Building Permit Application

Permit No.: B14003049

**RE: Building Permit B14003049
12126 Hayland Farm Way
Ellicott City, MD 21042**

FIRST FLOOR PLAN
 SCALE: 1/4" = 1'-0"
 03.00

FOUNDATION PLAN

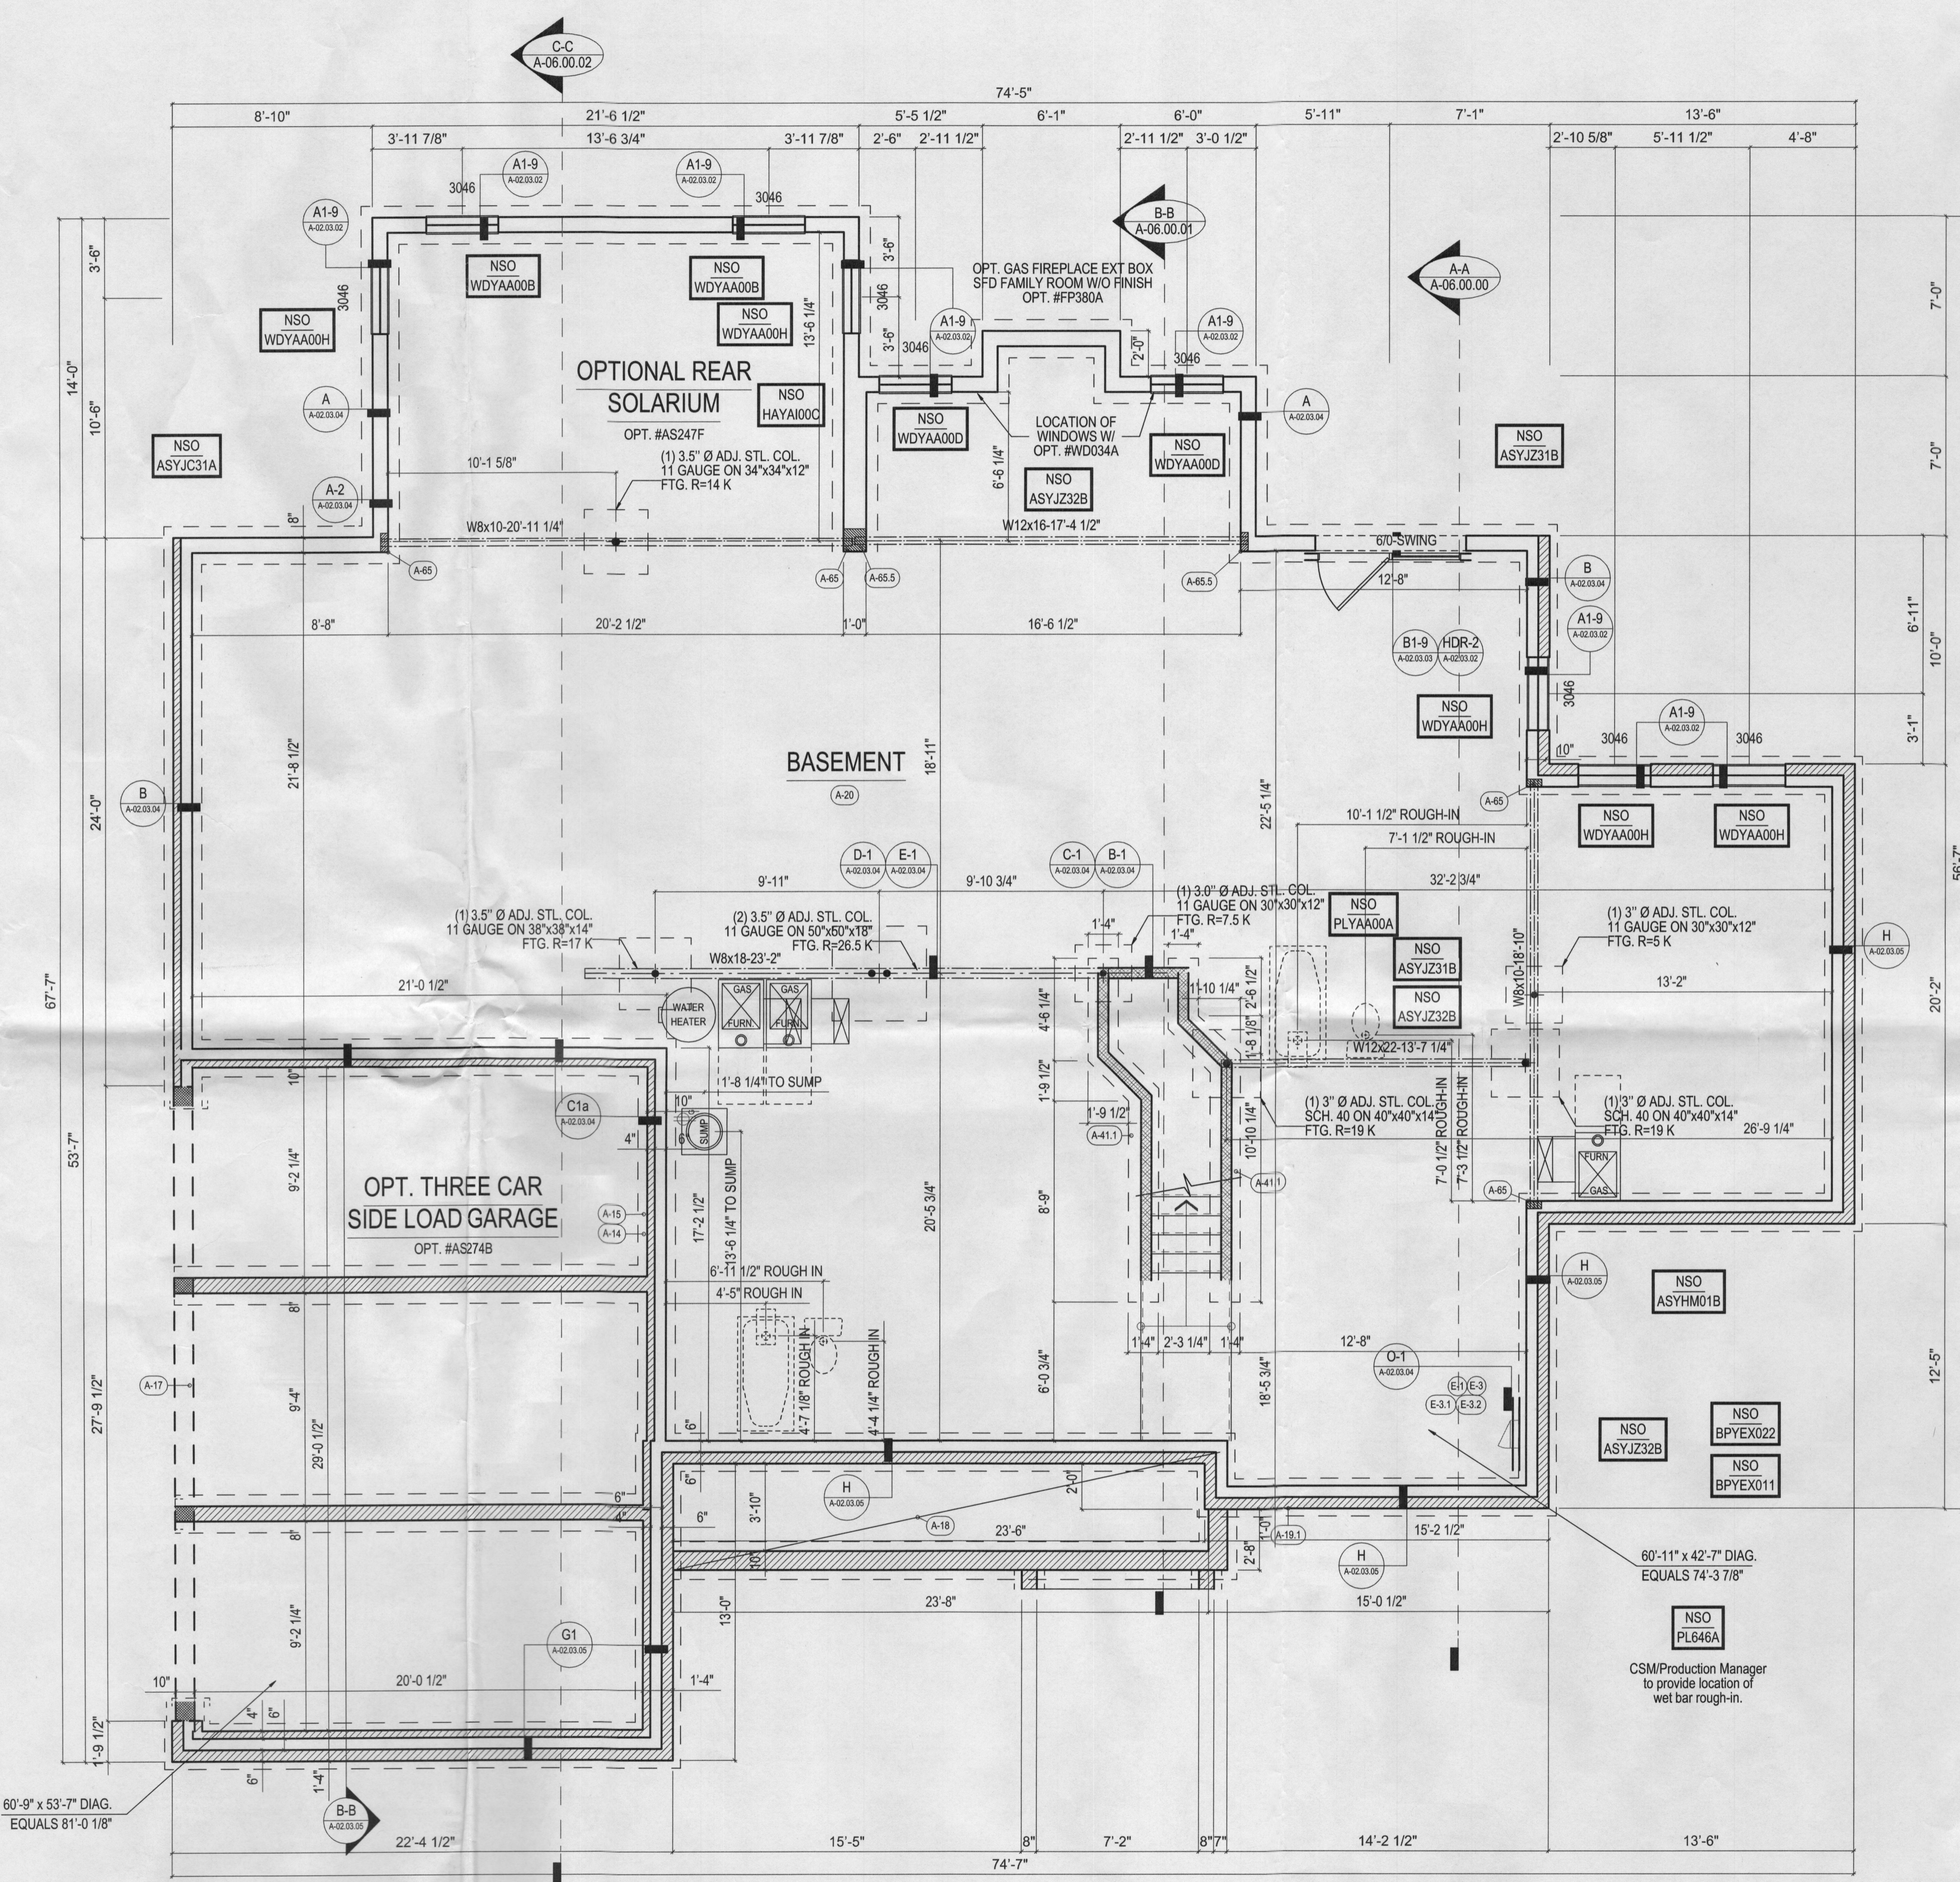
Good morning. It is not clear to me and the building permit doesn't say whether the basement is being finished-off. Please clarify.

Good morning. This permit# has an unfinished basement.
